In the Matter of  
NEXTERA ENERGY SEABROOK, LLC  
(Seabrook Station, Unit 1)

Docket No. 50-443-LA-2  
ASLBP No. 17-953-02-LA-BD01

Response to Request for Additional Information Regarding License Amendment  
Request Related to Alkali-Silica Reaction (CAC No. MF8260; EPID L-2016-LLA-0007)

Figure 1: P-M Combinations Cases (a) Section design with high steel ratio, (b) Section design with low steel ratio

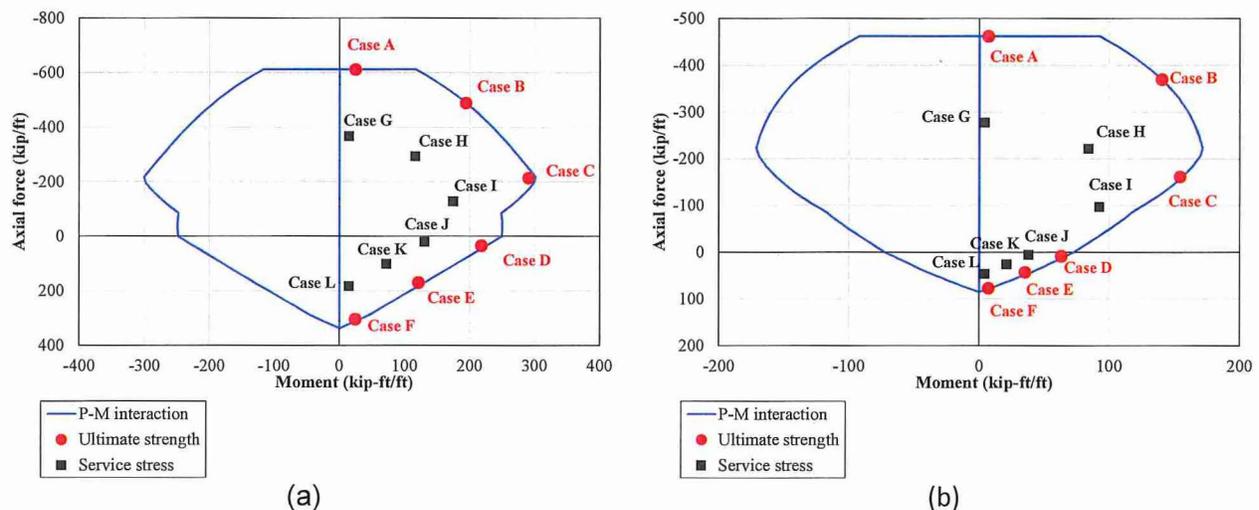
The member is first subjected to the combined axial force (P) and bending moment (M) due to external loads. Then internal ASR strains are increased from 0.0 to 2.0 mm/m. It should be noted that the 2.0 mm/m ASR strain used here is just an upper limit set for this parametric study and is not a limit set by MPR/FSEL large scale test programs. The ASR load simulates the self-straining behavior of placing the steel in tension and concrete in compression. Several cases of P-M combinations are considered as shown in P-M plots in Figure 1 and summarized in Table 1:

- Cases A through F represent factored load level forces near the section strength limits (demands on the P-M curve), and
- Cases G through L represent the expected service load conditions (loads at about 60% of Cases A through F).

**Figure 2: Stress in tension rebar of typical 2 ft thick member subjected to factored load level P-M and increasing ASR strain (a) section design with high reinforcement ratio, (b) section design with low reinforcement ratio**

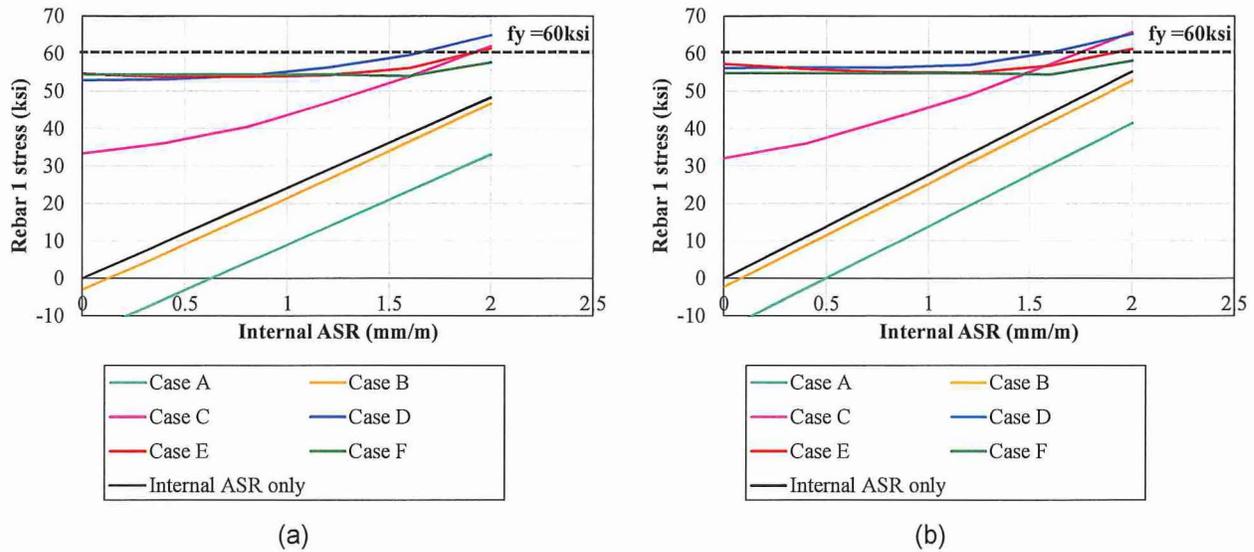
The relationship between the rebar stresses with the increasing level of ASR strain when the member has already been subjected to factored external load levels (Cases A through F) is shown in Figure 2 for members with high and low reinforcement ratios. The stress in the rebar is computed using a fiber section method, in which the section is divided into twenty thin layers with concrete represented with compressive stiffness only (no tension stiffness) and the reinforcement is represented with linear elastic behavior. The internal ASR expansion is modeled by applying autogenous (initial) strain to concrete fibers that will be restrained by the rebars. Details of the procedures and calculations leading to the reinforcement stress plots are presented for representative Case I in the Attachment 1.

The relationship between the rebar stresses and the increasing level of ASR strain when the member has already been subjected to service external load levels (Cases G through L) is shown in Figure 3 for members with high and low reinforcement ratios.

The following can be concluded from the results shown in Figures 2 and 3:

**Figure 4: Stress in tension rebar of typical 2 ft thick member subjected to ASR and increasing moment (a) section design with high reinforcement ratio, (b) section design with low reinforcement ratio**

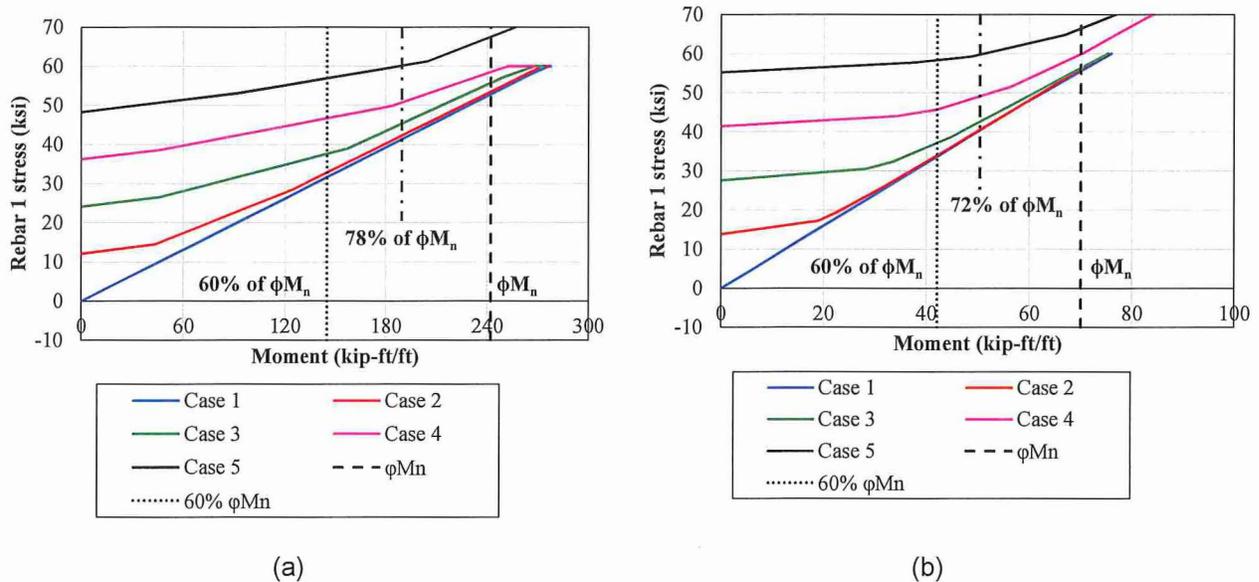
The relationship between the rebar stresses and the level of external bending moment is shown in Figure 4 for members with relatively high and low reinforcement ratios.

The following can be concluded from the results shown in Figure 4:

Figure 1: Results for Case I

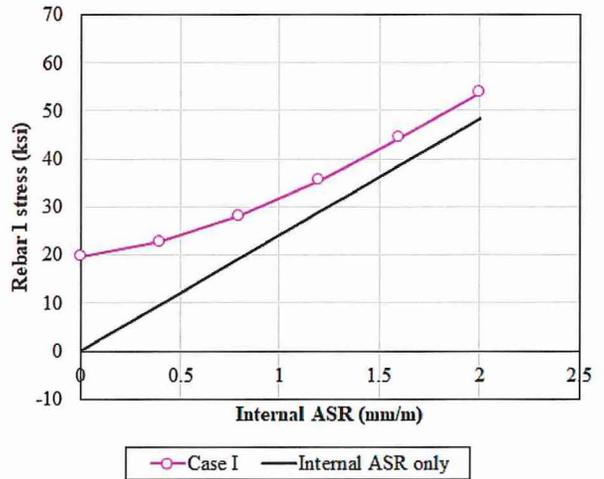
Table 1 summarizes the tensile stress in rebars corresponding to constant axial force and moment with an increasing ASR expansion. The results are also plotted in Figure 1b. This data is used to draw diagrams similar to what presented in Figure 3b of parametric study 1.

As an example calculation, Case I for a section with high reinforcement ratio is considered. The section is 2ft thick with 3000psi concrete that is reinforced with #11@6in. on both faces. The point corresponding to case I is highlighted on P-M interaction diagram provided in Figure 1. The amount of axial force and moment for Case I are -128.5kip/ft and 174.2kip-ft/ft, respectively.

Figure C1: Contour plots of vertical strains in the interior walls due to LC1

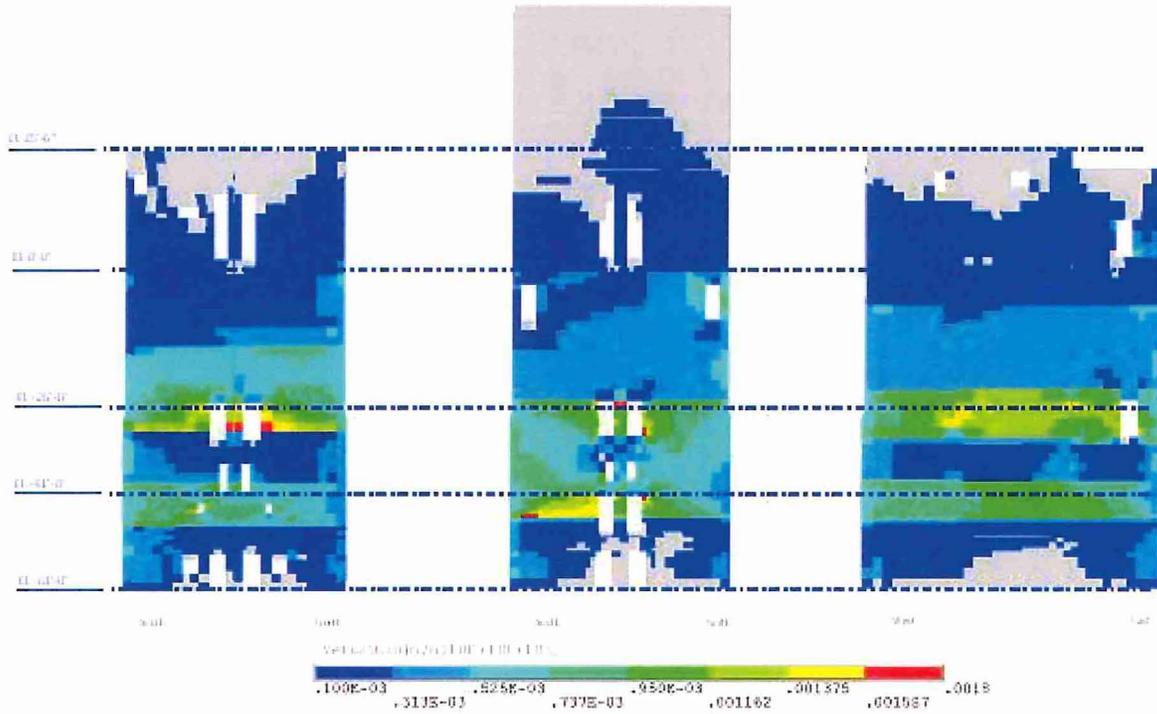
Figure C1 shows the contour plots of vertical strains in the interior walls due to LC1. The contour plots show that the overall vertical strains are reasonable compared to the yielding strain of rebars (i.e., 0.02% in/in). Localized strain concentration is observed close to the door openings at approximate El. (-) 30 ft. and El. (-) 45 ft.. Ductile distribution of local demands along the width of the interior walls is possible. As a result, localized strain concentration is not of concern.
